LEITH WALK

Leith Central Community Council's response to City of Edinburgh's
consultation on the Tram Extension to Newhaven

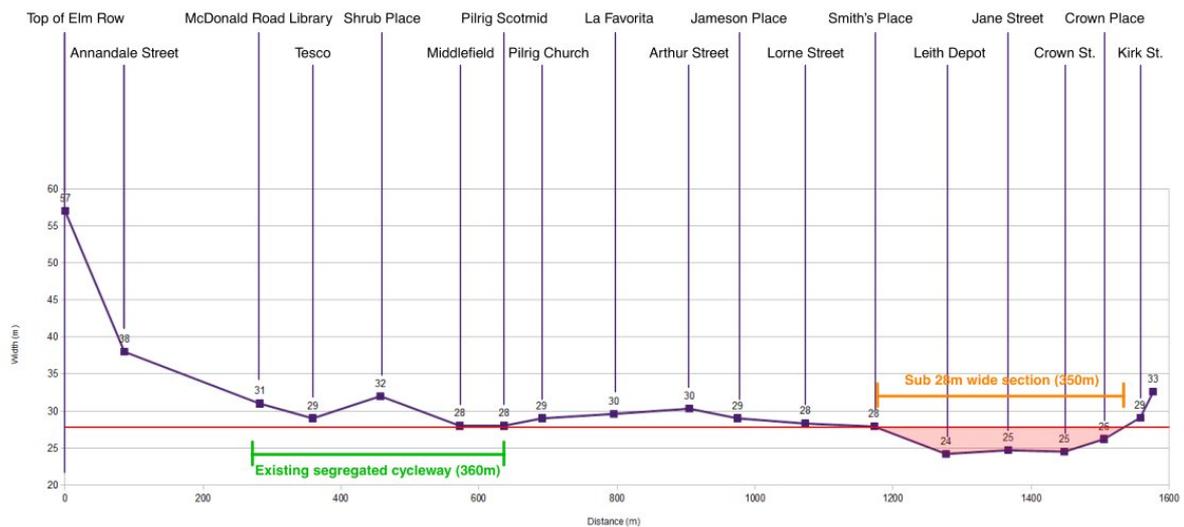
3. **Insufficient and 'illegible' crossing points.**

As D Wraight has acknowledged, there are many 'permeability' issues with the current plans. We advocate many more crossing opportunities – signalled, formal and informal – than currently envisaged.

To maximise connectivity, these should be where people expect them: at junctions and near tram and bus stops (with the location of the latter two matched to crossing points, not the other way around) and should follow an easy to understand design and location pattern:

- a. signalled: at all major junctions – Annandale, McDonald, Pilrig, Foot of the Walk

- b. formal: at all intermediate side streets – Albert, Dalmeny, Balfour, Lorne, Stead’s Place, Jane/Manderston
- c. formal: just behind all (most) bus stops (build-outs are insufficient) and at both ends of tram platforms
- d. informal: anywhere, by eliminating the central reservation

8. Asymmetric street layout.

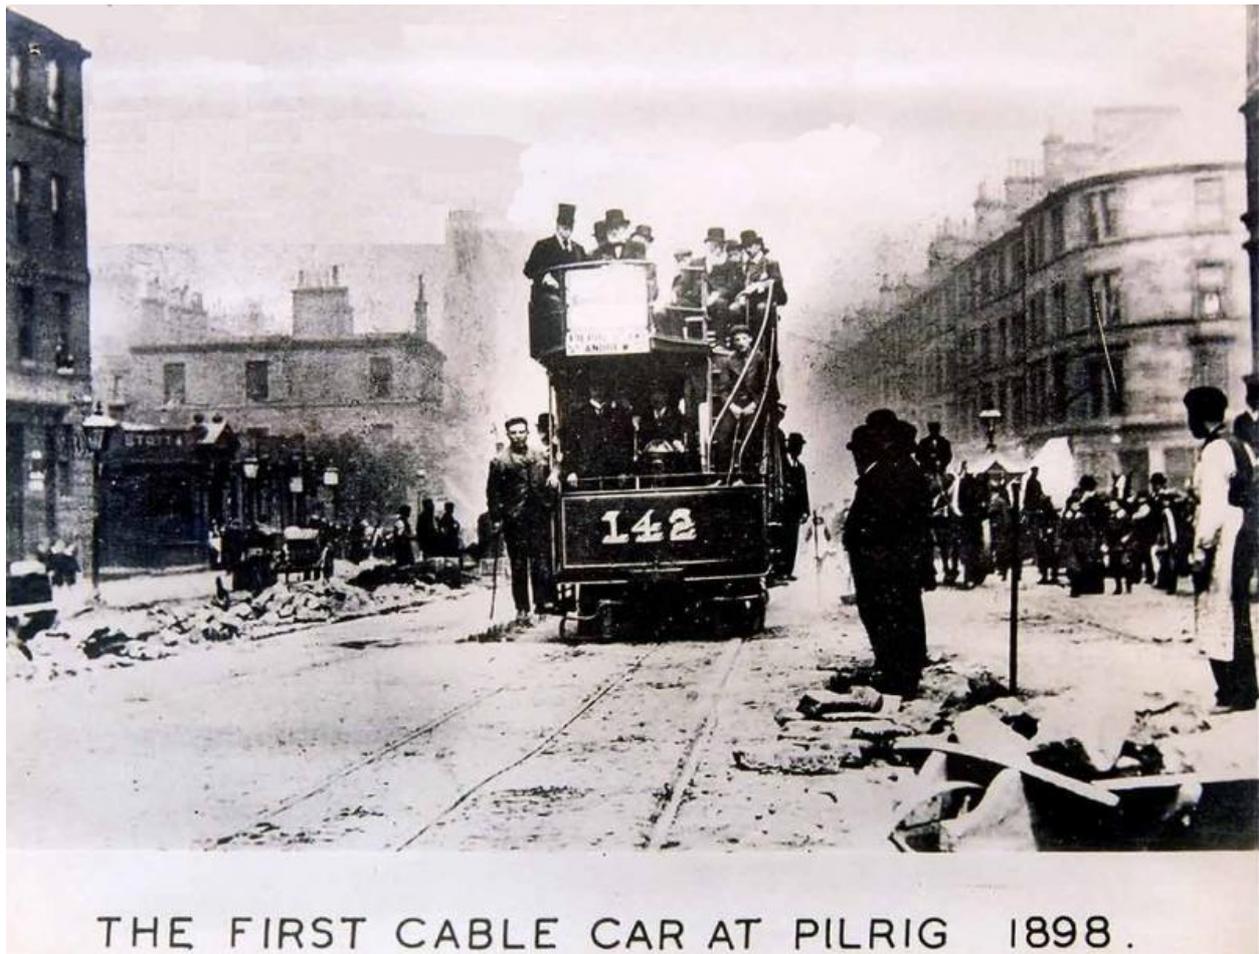
It is our understanding that the 'swept path' is at least 11m wide, while the requirement for two tram tracks, even with central reservation, is 7.4m. This would allow for a radical asymmetric layout: slightly offset tram tracks and motor traffic (possibly including loading/parking) and pavement on one side; green separation space, two-directional cycle path and pavement on the other.

We would love to hear that there is time to explore and consult on such a people-friendly layout.
